# VALUE ENGINEERING REPORT

SR 40 – Okefenokee Parkway  
STP00-0000-00(820), PI No. 0000820  
Charlton / Camden Counties

May 7, 2009

MACTEC Engineering and Consulting, Inc.  
3200 Town Point Drive NW, Suite 100  
Kennesaw, GA 30144

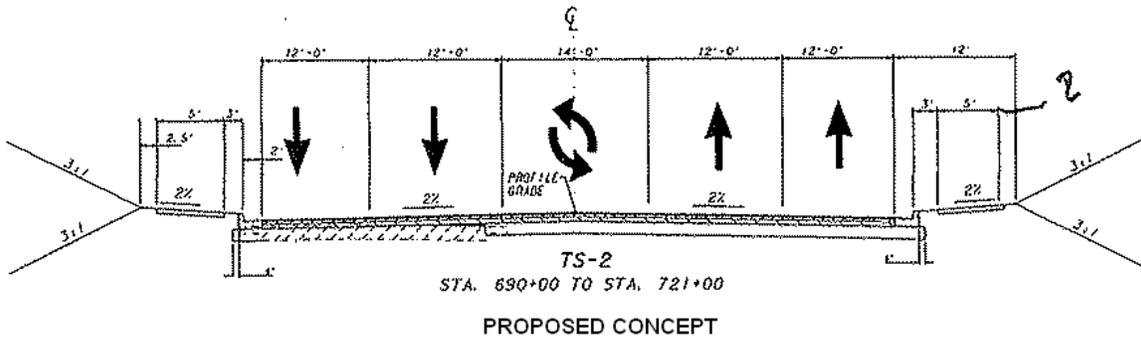
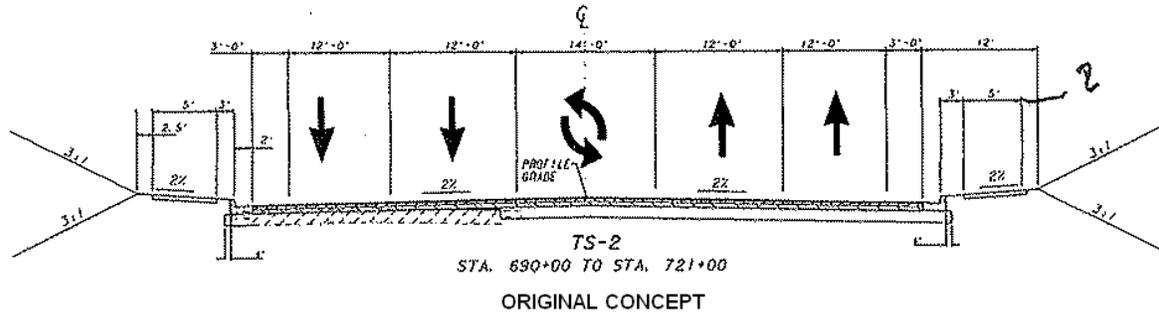
The proposed 5-lane urban roadway design results in a total typical section width of 92 feet. The reported reason for using a 5-lane urban section in this area is to reduce the width of the roadway to lessen the project’s impact on the area. Eliminating the dual bike lanes would reduce the total section width further lessening the project’s impact on the area.

Eliminating the bike lanes from this section should not impact safety due to the very low traffic volumes in this corridor. State Route 40 has very low traffic volumes and is only being widened to comply with the State’s GRIP program. The VE concept provides adequate safety for a roadway section with low traffic volumes and a posted speed of 45 MPH.

**Proposed Change:**

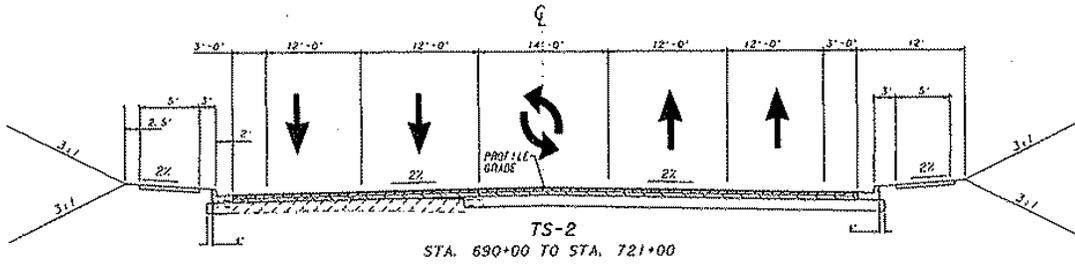
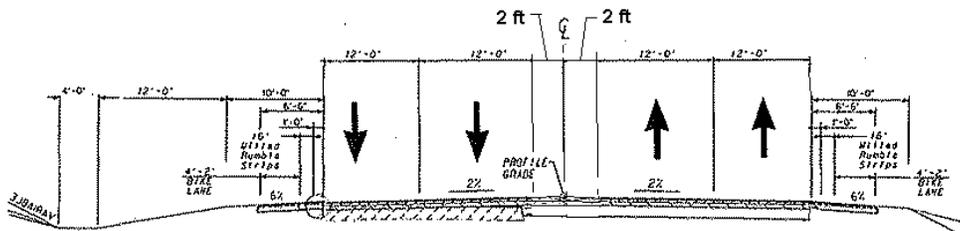
The proposed 5-lane urban roadway design results in a total typical section width of 92 feet. The reported reason for using a 5-lane urban section in this area is to reduce the width of the roadway to lessen the project's impact on the area. While the modified 4-lane roadway section has the same total section width, it eliminates the concrete curb & gutter, the concrete sidewalks, the dual bike lanes, and reduces the total amount of pavement.

The VE concept provides the same function as the current design and accommodates current and future traffic demands. State Route 40 has very low traffic volumes and is only being widened to comply with the State's GRIP program. This concept provides adequate safety for a roadway section with low traffic volumes and a posted speed of 45 MPH. This concept results in significant cost savings and would simplify / accelerate construction.

It is recommended that a modified 4-lane rural roadway be constructed in-lieu-of the 5-lane urban roadway. This modified 4-lane rural roadway would provide four 12-foot travel lanes, a 4-foot striped median, two 10-foot (6.5' paved) shoulders and two 10-foot ditches.

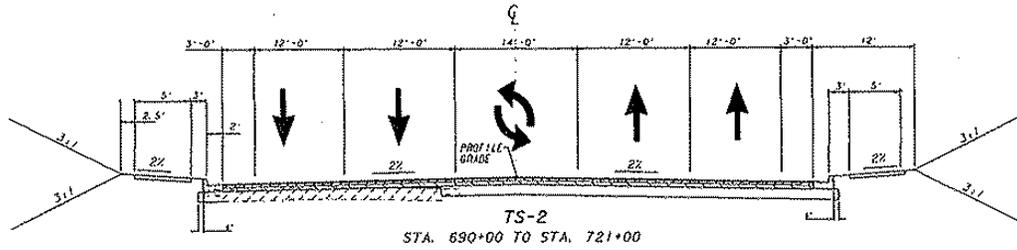
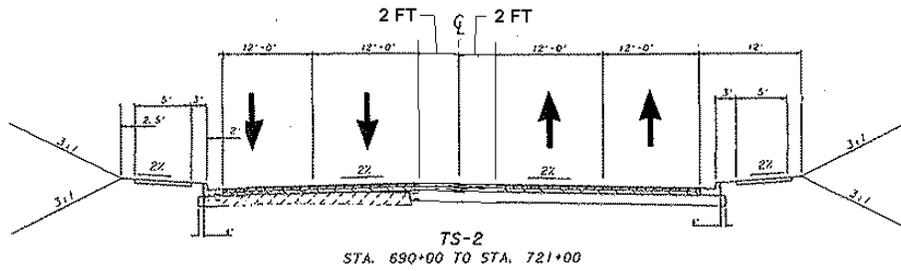
The proposed 5-lane urban roadway design results in a total typical section width of 92 feet. The reported reason for using a 5-lane urban section in this area is to reduce the width of the roadway to lessen the project’s impact on the area. The VE concept would reduce the total section width to 76 feet further lessening the project’s impact on the area.

Eliminating the 14-foot center turning lane and dual 3-foot bike lanes from this section should not impact safety. State Route 40 has very low traffic volumes and is only being widened to comply with the State’s GRIP program. The 4-lane modified urban roadway provides the same function as the original design. This concept provides adequate safety for a roadway section with low traffic volumes and a posted speed of 45 MPH. It also results in significant cost savings and would simplify / accelerate construction.

It is recommended that a modified 4-lane urban roadway be constructed in-lieu-of the 5-lane urban roadway. This modified 4-lane urban roadway section would provide four 12-foot travel lanes, a 4-foot striped median, and 12-foot urban shoulders.

<b>IDEA No.:</b> R-1	<b>Sheet No.:</b> 1 of 3	<b>CREATIVE IDEA:</b> Eliminate asphalt curb from under the guardrail.
-------------------------	-----------------------------	---------------------------------------------------------------------------

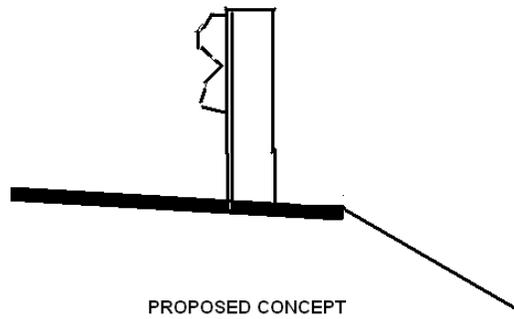
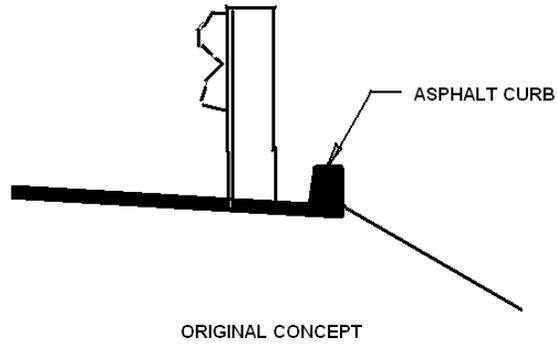
This project is located in an extremely flat area. The installation of asphalt curbs are designed to comply with the GDOT Design Policy Manual Section 6.5.2, which states “Asphaltic curbs are used to control runoff and erosion on high fills (>20-ft) with 2:1 side slopes or in guardrail sections along rural roadways.” Based on reviewing the photo log of the project the following observations were made:

- The height of the fill slopes with existing guardrail appear to be less than 5 feet.
- The existing guardrail installations do not have asphaltic curb behind them.
- No erosion or shoulder / slope instability was noticeable in the video logs.

Since the proposed divided four-lane roadway will incorporate the existing (resurfaced) two-lane roadway into its typical section, its grade will remain essentially the same as the existing road. Keeping the existing roadway grade will result in the new road having the same extremely flat side slopes as the existing road. This will reduce the probability of erosion problems on the shoulders / side slopes.

<b>IDEA No.:</b> U-1	<b>Sheet No.:</b> 1 of 4	<b>CREATIVE IDEA:</b> Eliminate both sidewalks along the 5-lane urban roadway section.
-------------------------	-----------------------------	-------------------------------------------------------------------------------------------

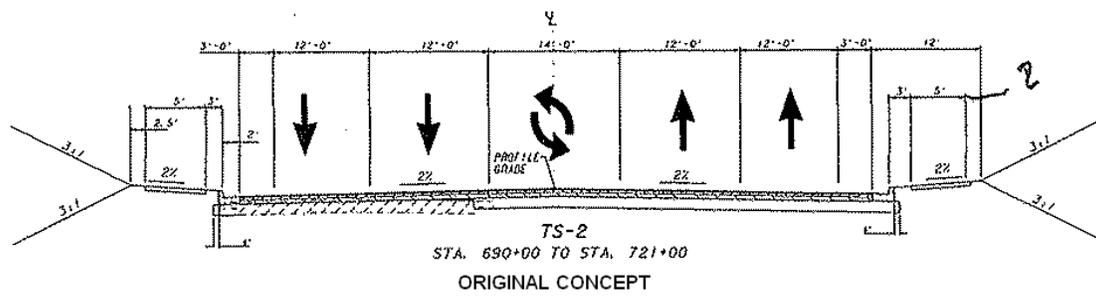
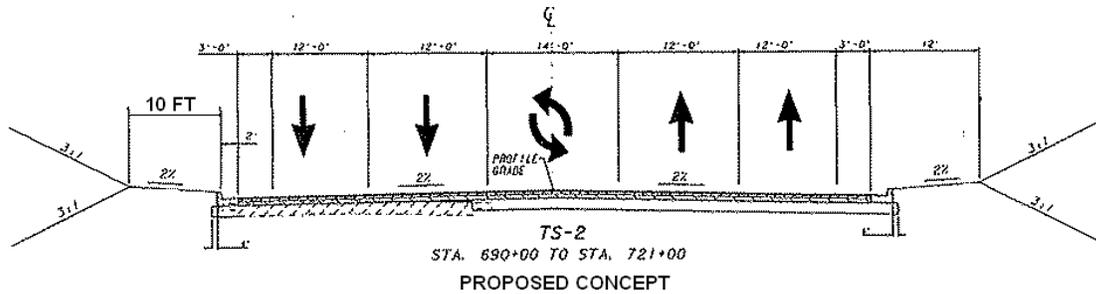
This entire project is in a very rural area where pedestrian traffic is extremely low, so the need for sidewalks is unwarranted.

It is recommended that both 5-foot concrete sidewalks be eliminated in the proposed 5-lane urban roadway section between Station 690 and Station 721.
